## Official Recall Notification U.S. Federal Boat Safety Act: Power-Assisted Steering Pump and Pulley Replacement Required

NOTICE
Revised August 2018. This bulletin supersedes the previous MerCruiser bulletin number 2018-05 August 2018 and OEM bulletin number 2018-04 August 2018.

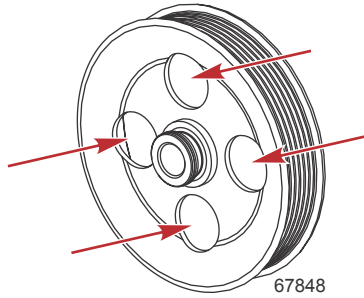
- If the power-assisted steering pump pulley has windows, then replacement is not required.

**Pulley has windows; replacement is not required**

- If the power-assisted steering pump pulley has a solid face (does not have windows), then the pump must be replaced. Follow the instructions provided in this service bulletin and the appropriate service manual, as indicated.

**Pulley has no windows; pump must be replaced**

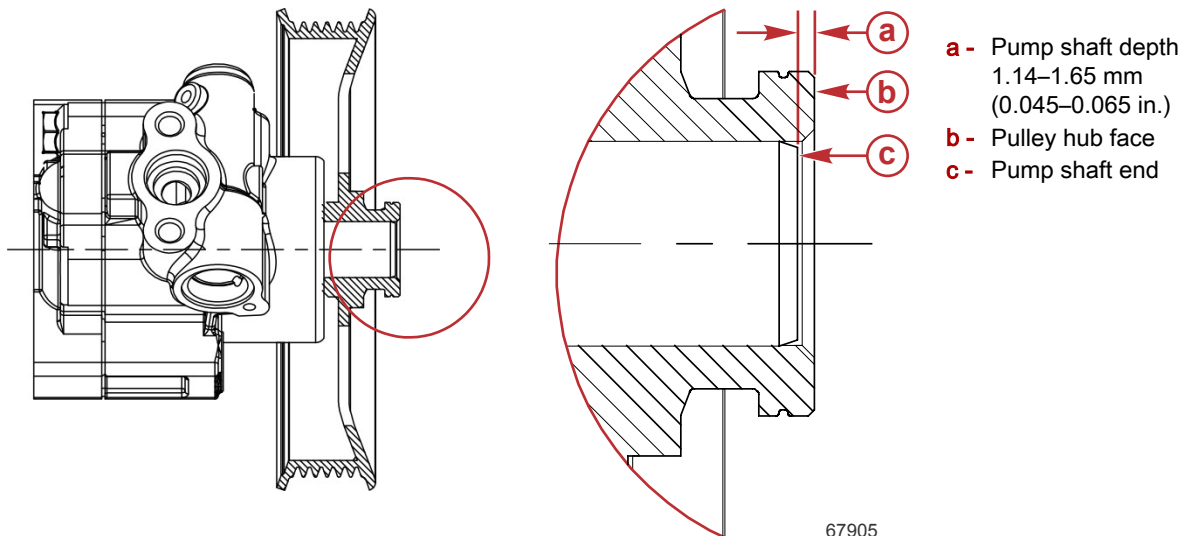
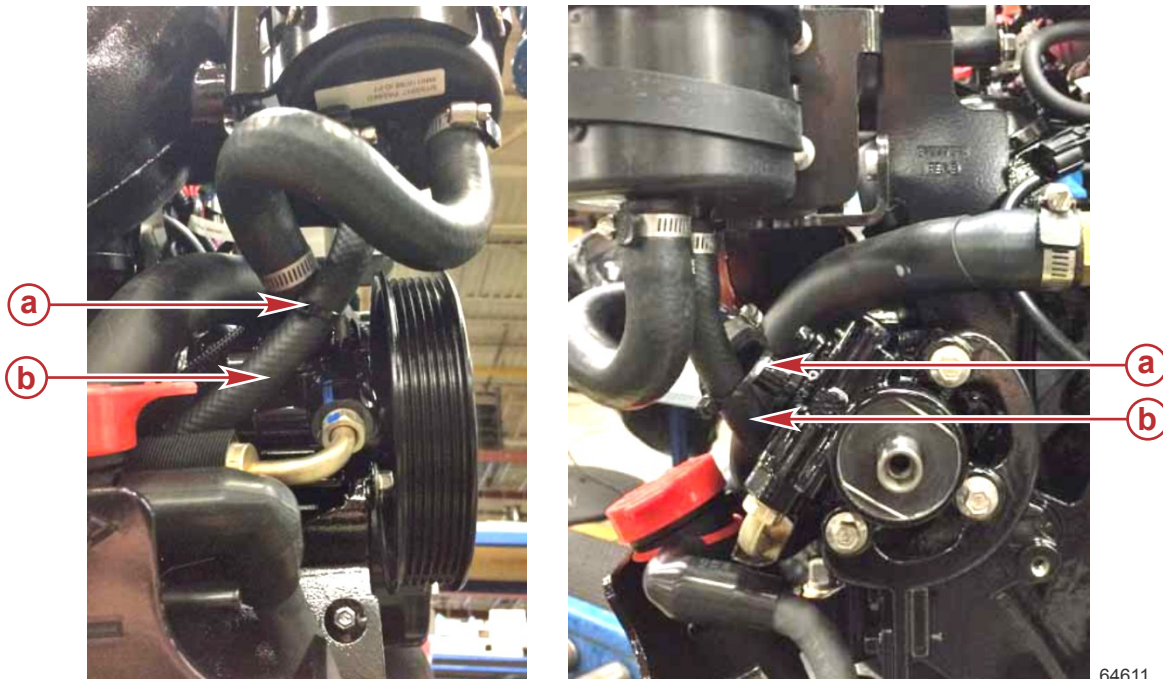
- f. Turn the pulley pusher nut until the pulley hub face is 1.14–1.65 mm (0.045–0.065 in.) from the end of the shaft.

**Cable tie location**

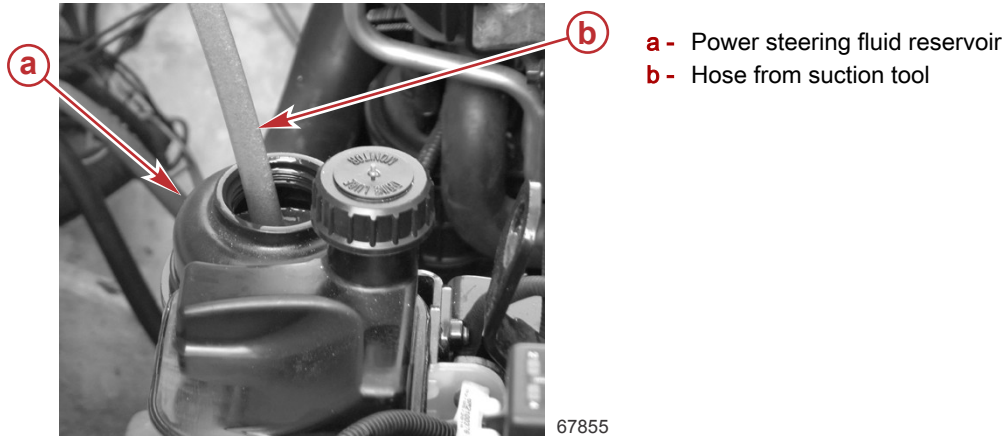
3. Remove the tool and install the serpentine drive belt. Refer to the appropriate engine service manual.
4. **For 4.5L/6.2L sterndrive models**—Install a cable tie to secure the power steering return hose to the power steering pump. This will ensure that the return hose will not contact the power steering pulley.
